Proposed amendments to approved drawings 23/00189/LBC are shown in red.

**LITTLE JERICHO
BLACKMORE**

PROPOSED GROUND FLOOR PLAN

242.12G

Ground Floor Plan

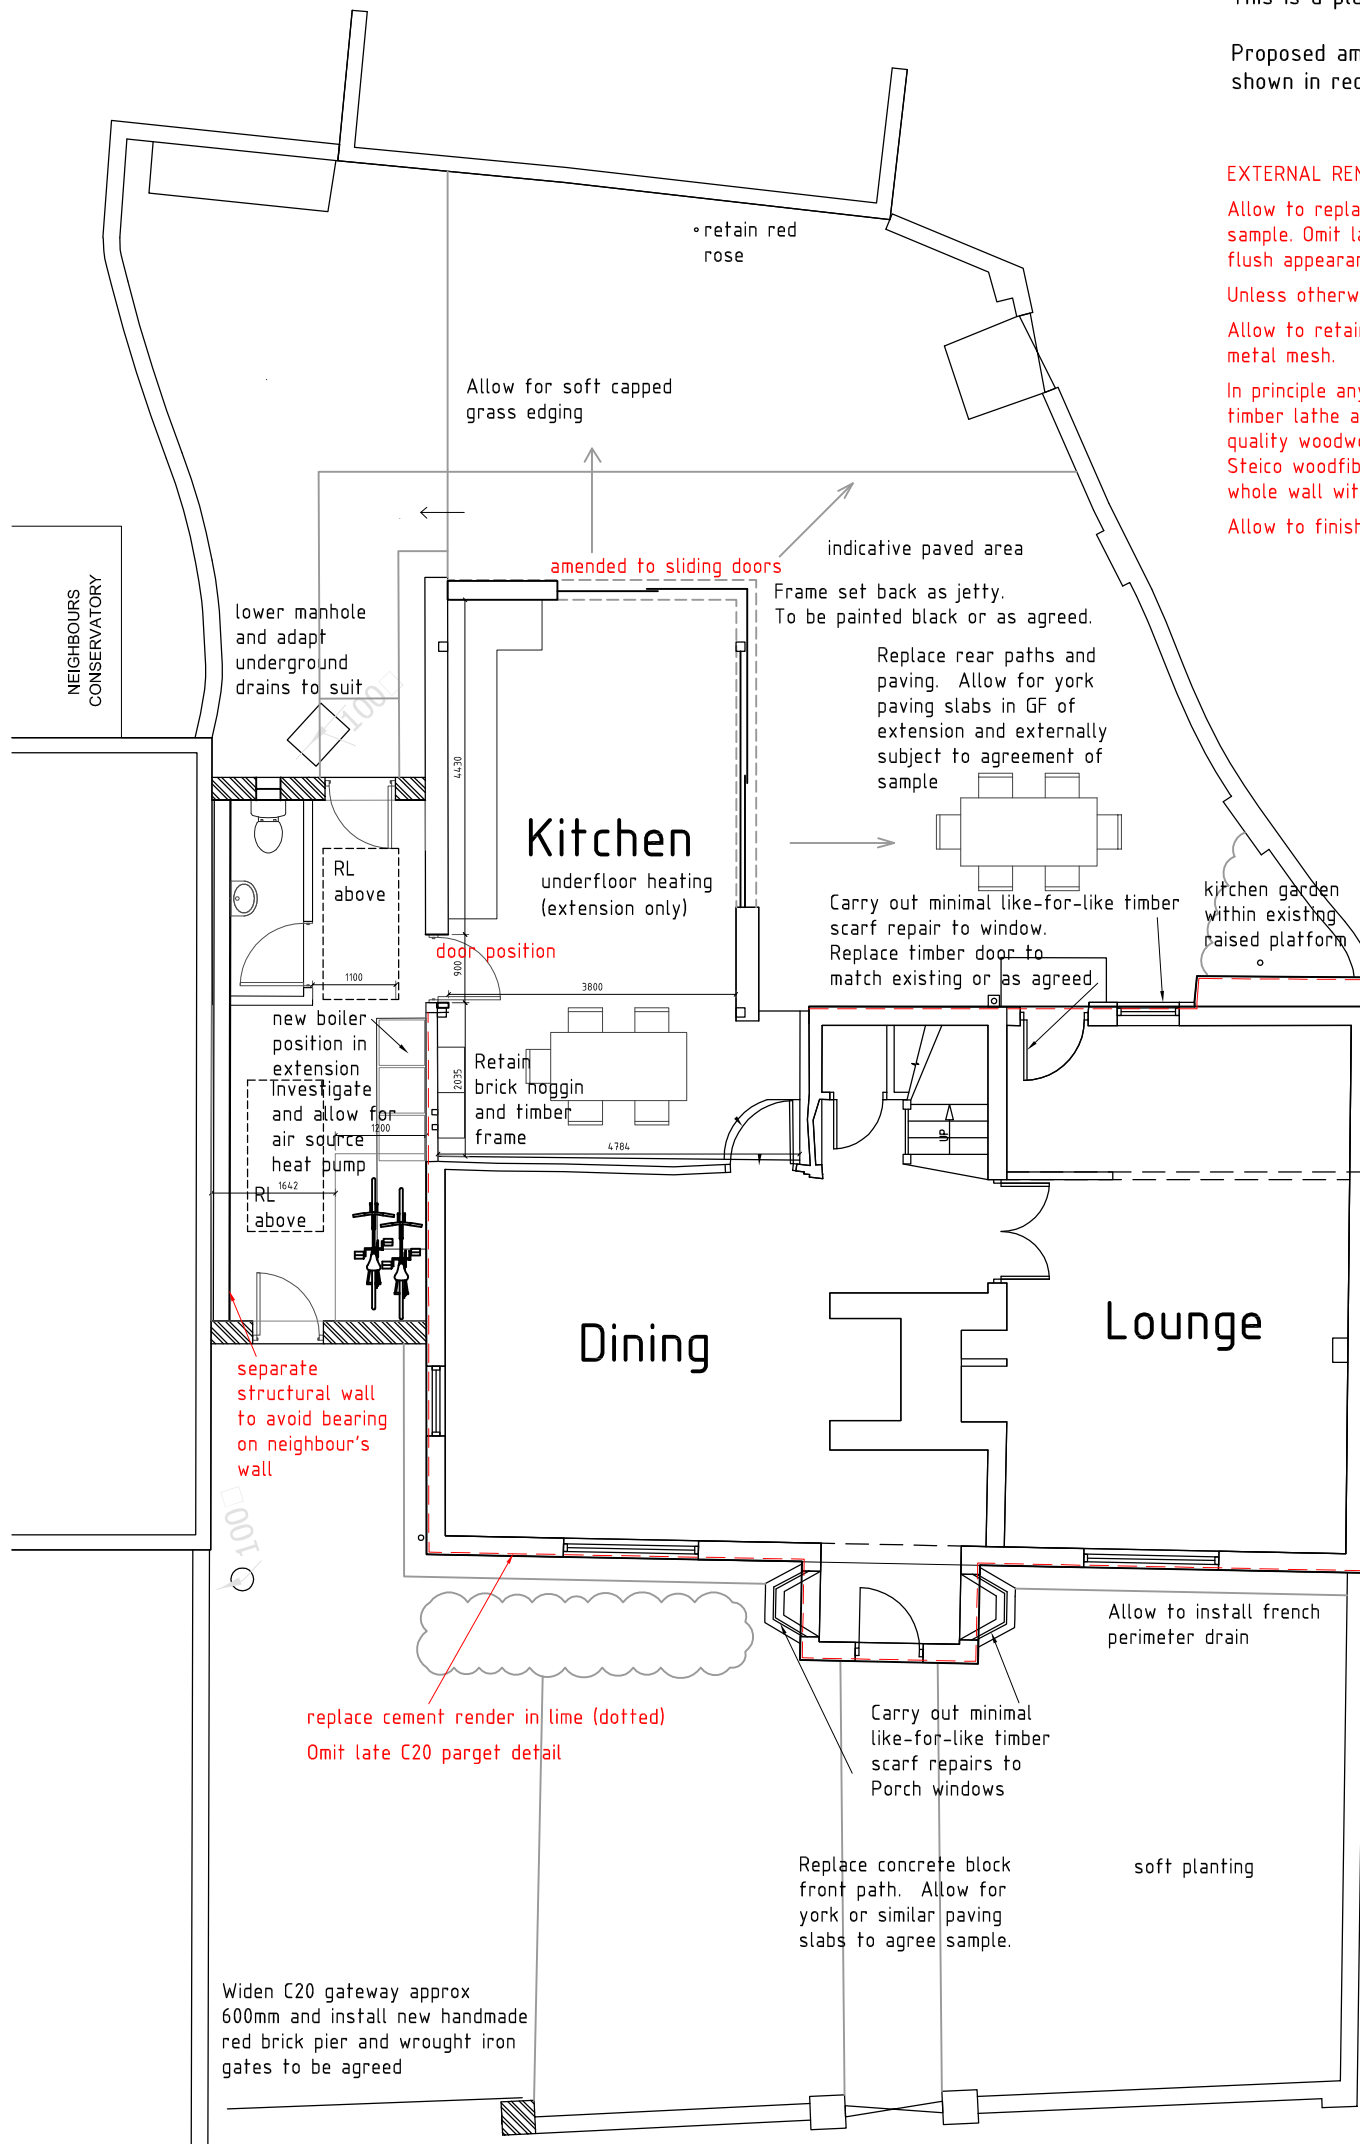
Allow to replace late C20 cement render in lime subject to agreement of render sample. Omit late C20 bottle parget panel detail to reinstate appearance to the flush appearance of the historic photograph shown in the Heritage Statement.

Allow to retain any sound historic lathes that survive and to carefully remove metal mesh.

In principle any areas retaining historic lathes are to be repaired in matching timber lathe and the metal mesh substrate is to be replaced with 15mm external quality woodwool or similar agreed breathable substrate. Allow to insulate in Steico woodfibre or similar breathable insulation batts if practical to do to a whole wall without disturbance of historic fabric and without cold bridging.

Allow to finish in Anglia Lime external lime render mix.
